SUBJECT: Contract Number W912P8-09-D-0046 0008, WBV-14c.2 - Westwego to Harvey Canal, Hurricane Storm Damage Risk Reduction System, New Westwego P.S. to Orleans Village, Phase 2, First Lift Levee and Floodwalls at Westminster Pumping Station, Jefferson Parish, LA

AMENDMENT OF SOLICITATION/MODIFICATION OF CONTRACT

CO-001 Government Furnished Sheet Piling

Contract W912P8-09-D-0046 0008, WBV-14c.2 - Westwego to Harvey Canal, Hurricane Storm Damage Risk Reduction System, New Westwego P.S. to Orleans Village, Phase 2, First Lift Levee and Floodwalls at Westminster Pumping Station, Jefferson Parish, LA is hereby modified to remove approximately 2,346 SF of Contractor Furnished PZ-27 Sheet Piling and replace with 2,520 SF of Government Furnished PZ-27 Sheet Piling.

SHEET IDENTIFICATION
C-201

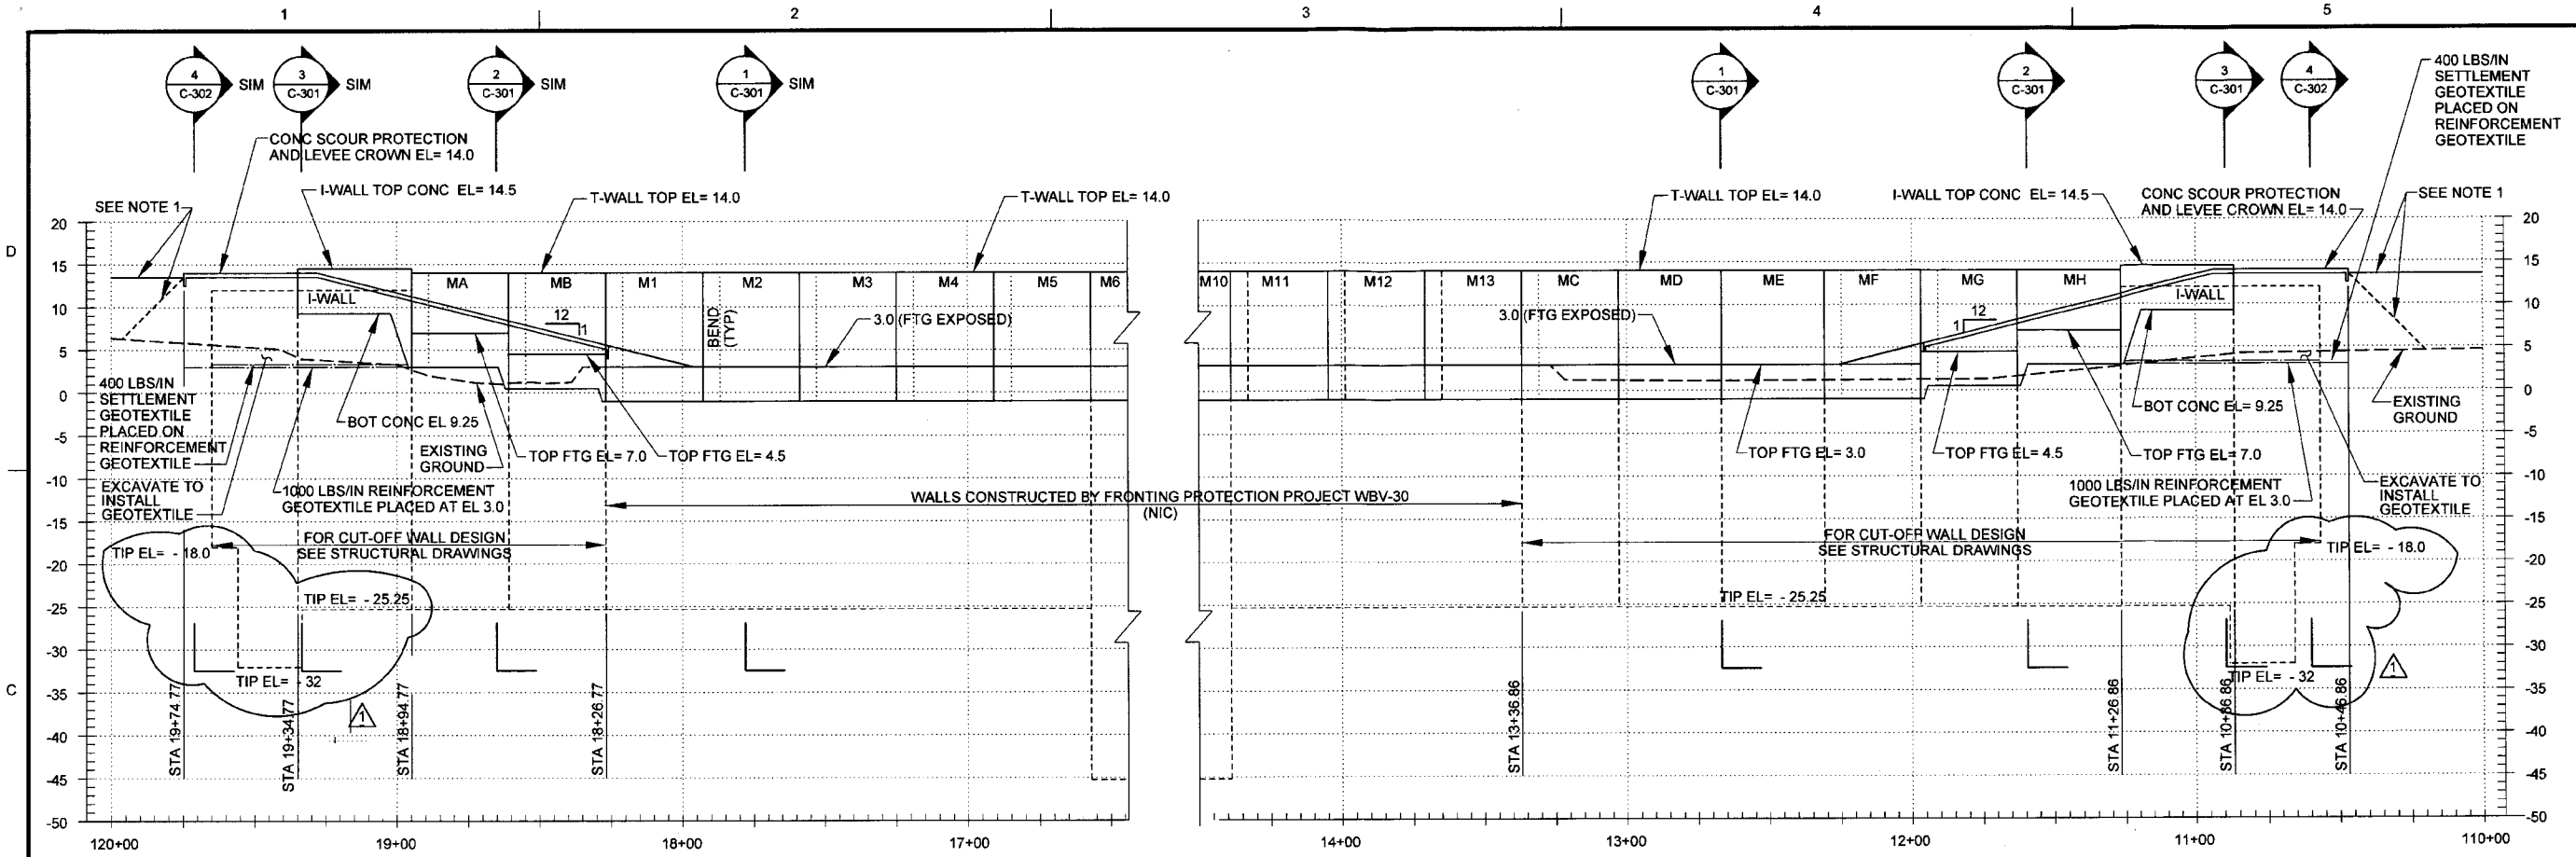
Drawing C-201 and S-401 Replace existing drawing C-201, with revised drawing C-201, mark 1, dated 8/10/10.

MARK	DESCRIPTION	DATE	APPR.
1	ADD GOVERNMENT FURNISHED PZ-27	9-10-10

SHEET IDENTIFICATION
S-401

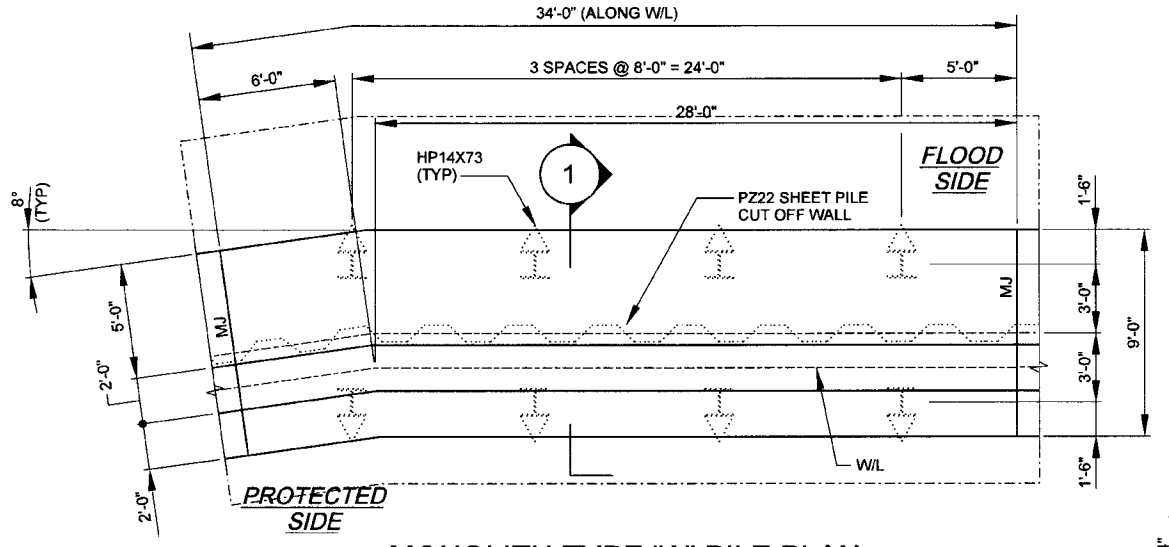
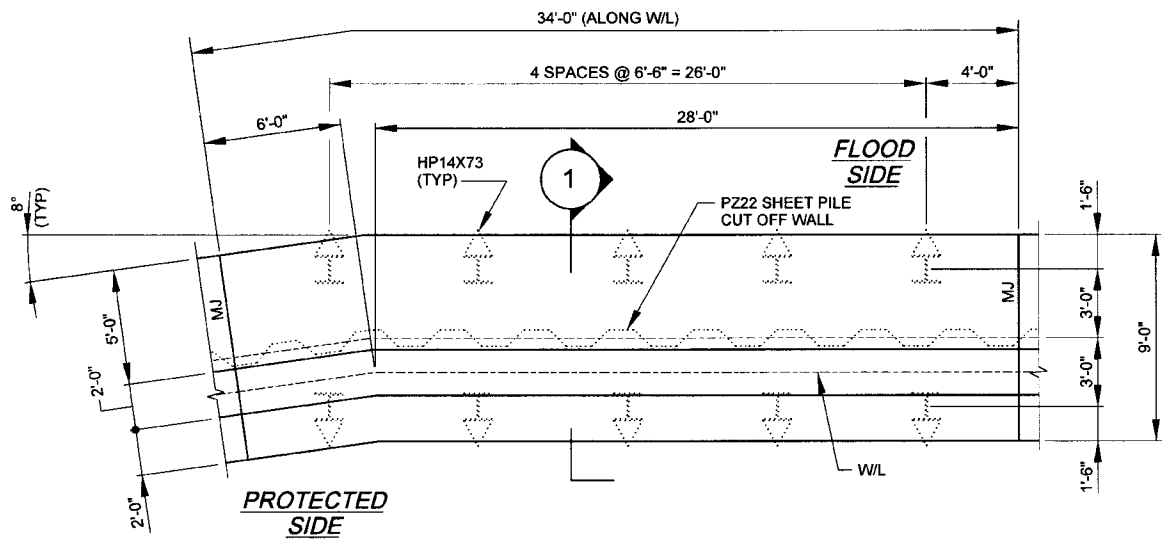
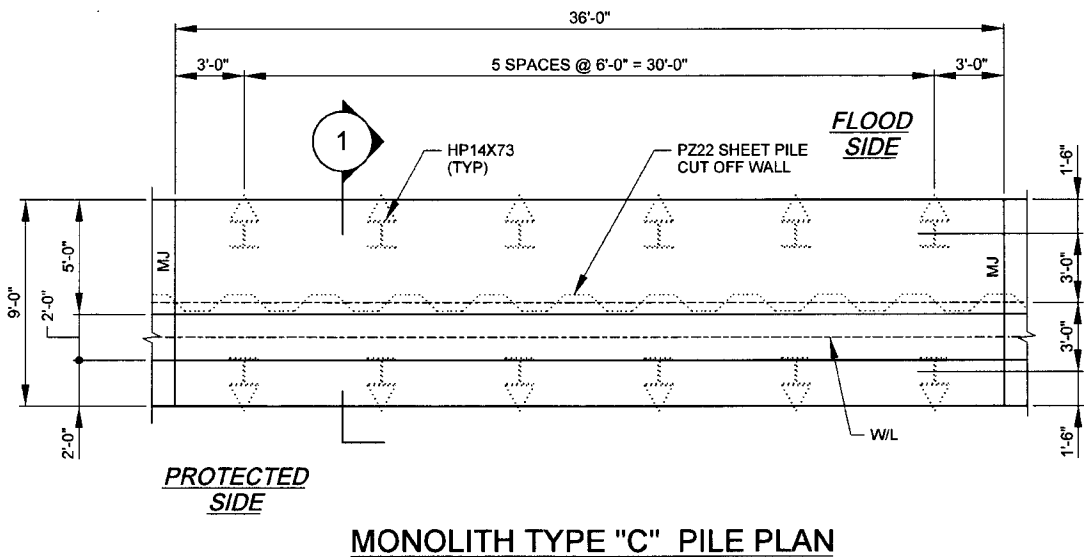
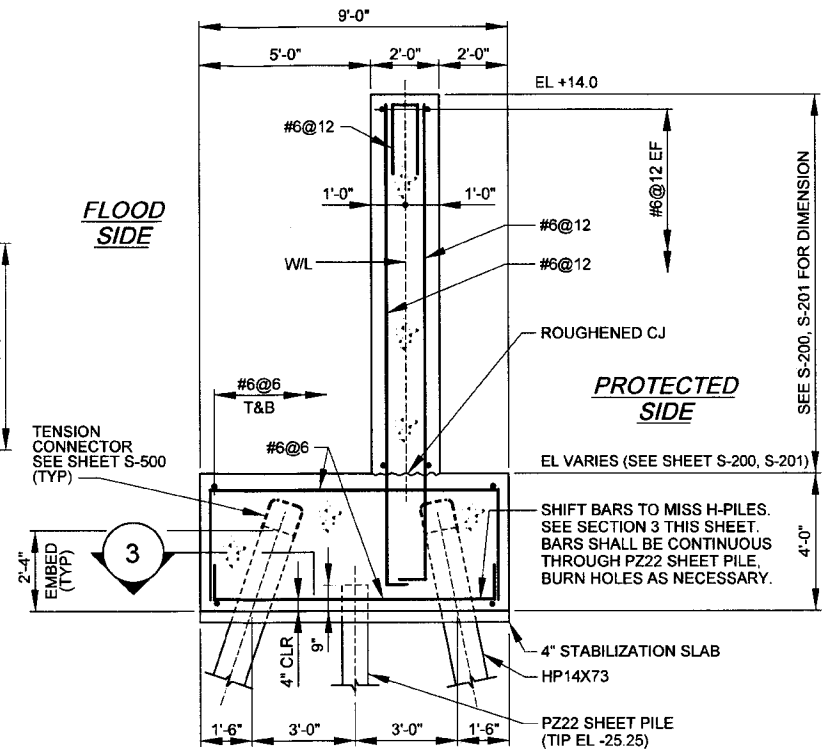
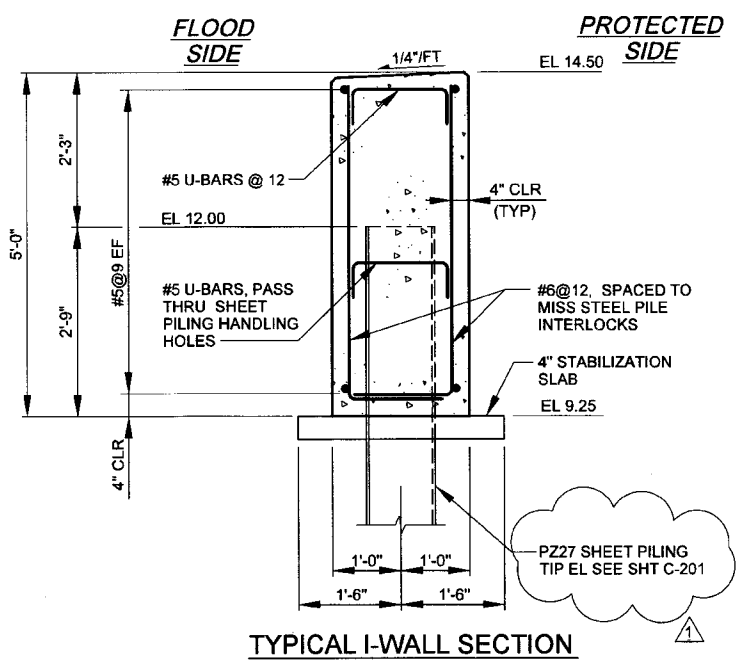
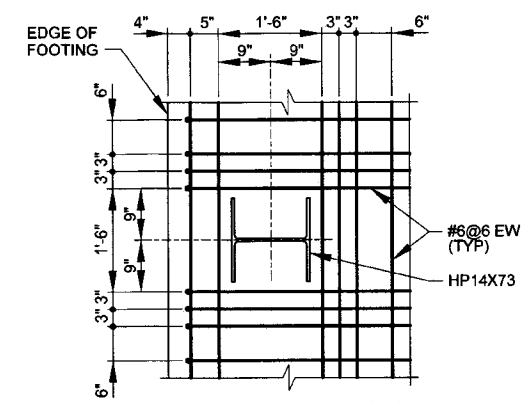
Replace existing drawing S-401, with revised drawing S-401, mark 1, dated 8/10/10.

MARK	DESCRIPTION	DATE	APPR.
1	ADD GOVERNMENT FURNISHED PZ-27	8-10-10

SHEET IDENTIFICATION
C-10

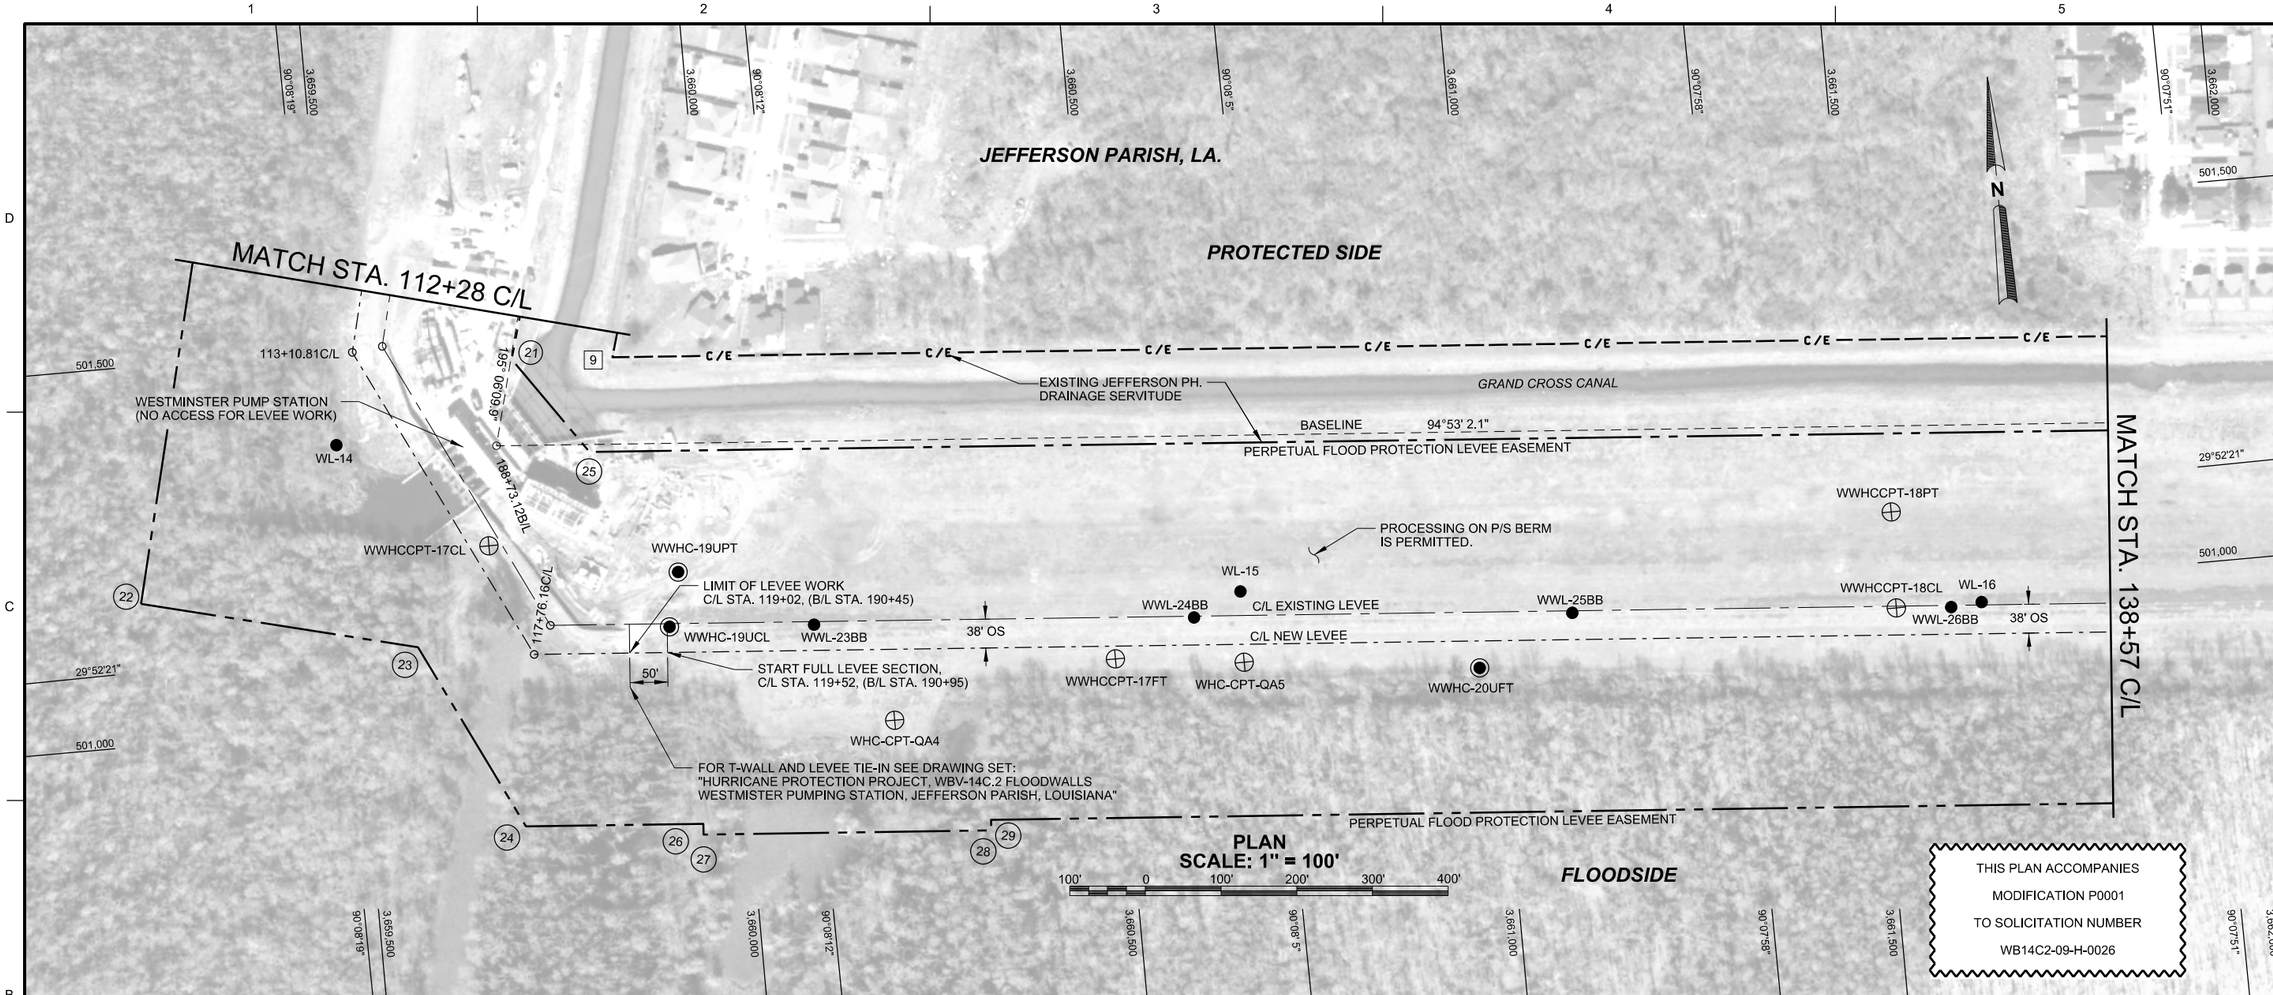
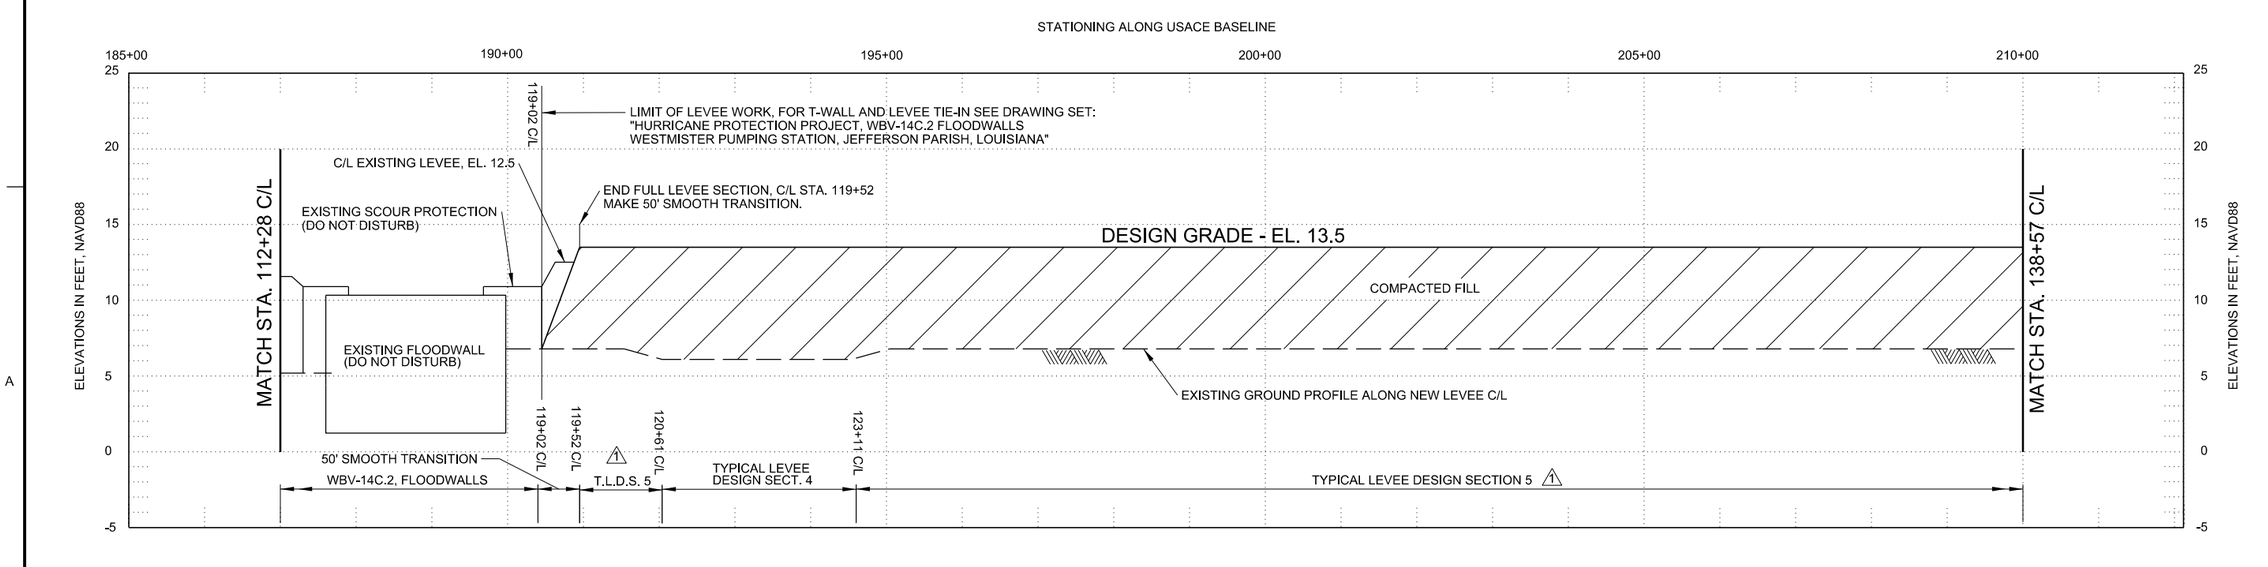
MARK	DESCRIPTION	DATE	APPR.
1	MOD# P0001 - REVISED TYPICAL SECTION LIMITS IN PROFILE.	03/15/11	B.J.L.
